有關運輸署對 A/YL-KTS/1057 的查詢

Appendix 2
Location: DD 106 Lot 480 (Part)
DD 106 Lot 482 (Part)
OZP: S/YL-KTS/15
District: Kam Tin South
Zoning: Other Specified Uses (Rural Use)
Date: 13 February 2025

Proposed Layout Plan
擬議佈局平面圖
擬議臨時貨倉（危險品倉庫除外）
連附屬設施（為期3年）
Proposed Temporary Warehouse (excluding Dangerous Goods Godown) with Ancillary Facilities for a Period of 3 Years

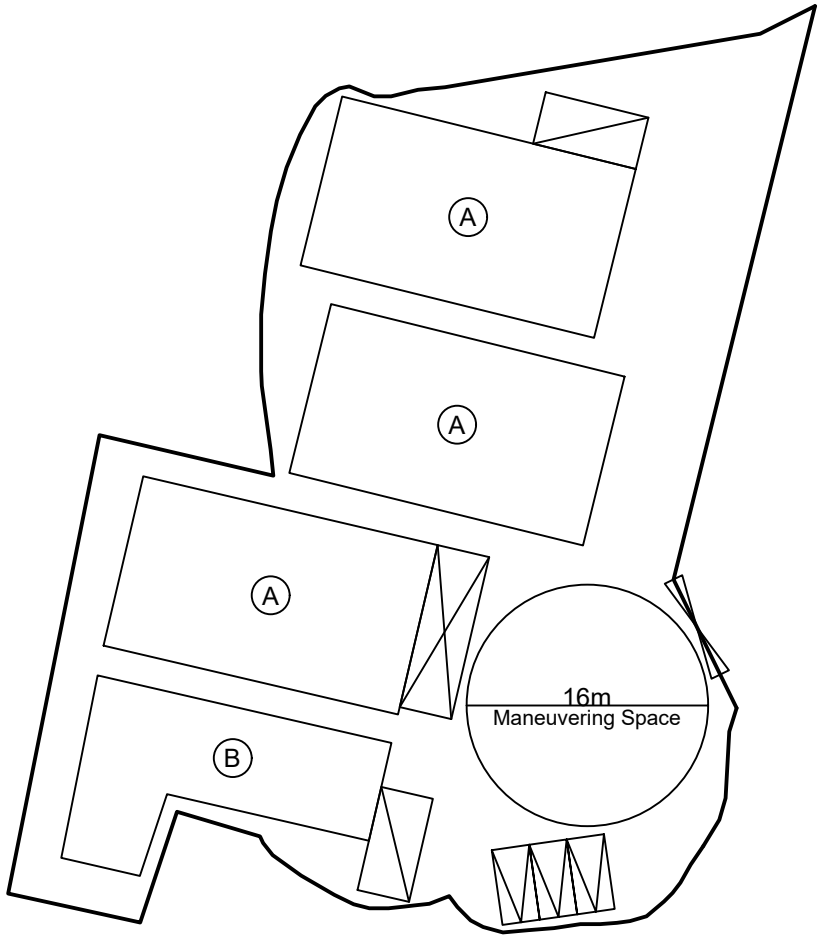
進入本申請地點的人士可使用錦上路，再以小徑進入申請地點。錦上路為一條雙線雙程的道路，設計容量為每小時 800 輛車輛。本申請的車流量少，不會對附近交通造成負面影響。此外，小徑的闊度上大多數能足夠讓兩輛平行通過，闊約 5-6 米，車輛有足夠的位置通過及進行調動。

申請地點的出入口約 7 米闊。
